Kennecott Eagle Minerals

Subject: Response to Cadmus Group Comments Titled “Comments on Responses to Request for Additional information (Class V treated Water Infiltration System Application): Final Report.” Kennecott Eagle Minerals Company (KEMC), UIC Permit Application Number MI-103-5W20-0002

KEMC Response to Cadmus Report Entitled: Comments on Responses to Request for Additional Information (Class V treated Water Infiltration System Application): Final Report

Figure 4. Lithology Fence Model from Southwest

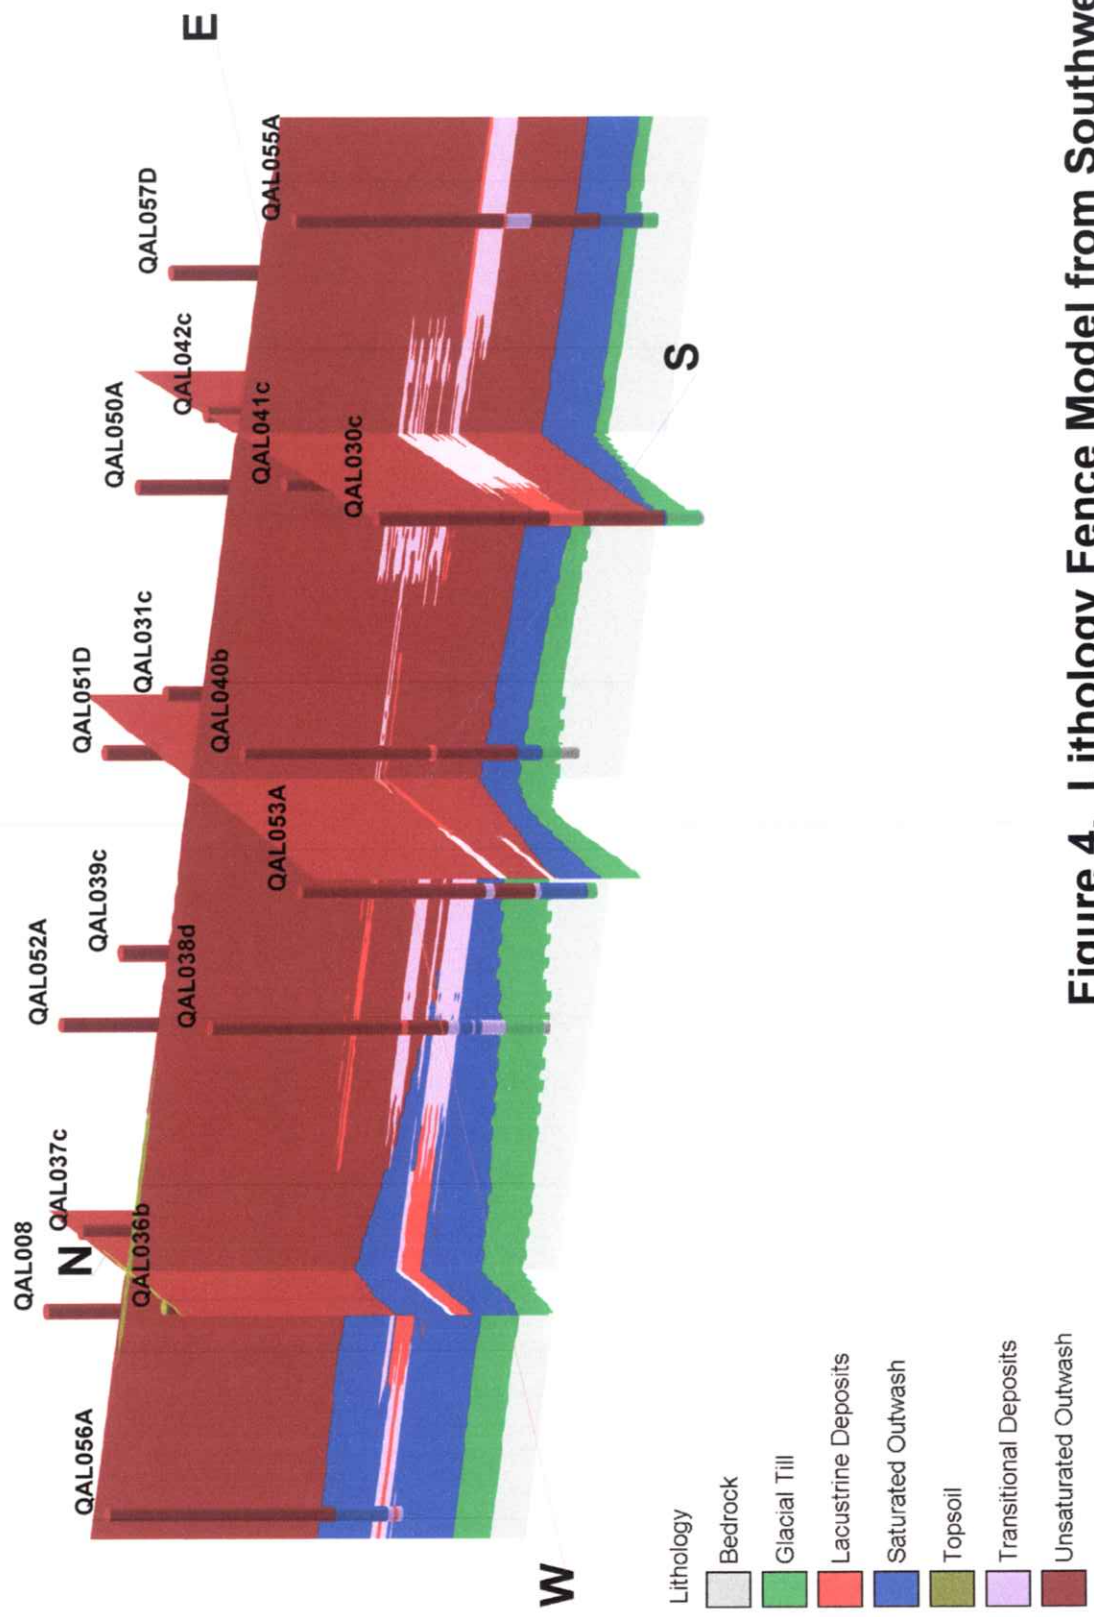
Cadmus Follow-up to KEMC 8-21-2008 Response to Comment No. 3: *The infiltrometer results do not provide the necessary information at depth, in general, and in the vicinity of the clay layer, in particular. If the clays observed in the borings from the site are continuous, then they, not the sands, will dominate infiltration behavior at the site. The continuity of the clay layer should be explored. To do this, we suggest constructing a 3-D model using a program such as RockWorks or Target to better visualize the configuration of clay at this location. The cross-sections in the report are insufficient for determining the continuity of the clays.*

KEMC 2-20-2009 Answer to Cadmus Comment No. 3: In order to provide an improved visualization of the continuity of hydrostratigraphic units, a stratigraphic model of the Quaternary alluvial deposits of the TWIS area has been constructed using data from the 17 soil borings located within and immediately adjacent to the TWIS area. These were provided in the full response to EPA comments (North Jackson Company, 2008) in a letter dated November 21, 2008. Two illustrations of the stratigraphic model for

improved visualization of the discharge area are contained in Figures 4 and 5 located at the end of this document.

Figure 4 provides a representation of the TWIS area stratigraphy. The orientation of the model (viewed from the southwest) is aligned with the regional groundwater flow direction. The representation illustrates that the lacustrine (clay-rich) deposit is present in the northwest portion of the area. The presence of the clay-rich material coincides with mounding of the regional water table in the northwest portion of the TWIS area. Where the clay-rich material is largely absent (towards the southeast), water table mounding does not occur. Although there are some thin (less than 4 feet thick), discontinuous stringers of transitional deposits above the saturated zone, they do not significantly impede natural infiltration, as evidenced by the absence of a perched aquifer associated with these deposits within the TWIS area.

In both model representations, the TWIS area is dominated by a relatively thick sequence (up to 100 feet) of unsaturated outwash sand. This material was adequately characterized by the infiltration tests performed for the HS Report. The other consistently continuous unit in the unconsolidated sequence is the basal till (poorly sorted clay/sand/gravel mix) unit directly overlying bedrock.
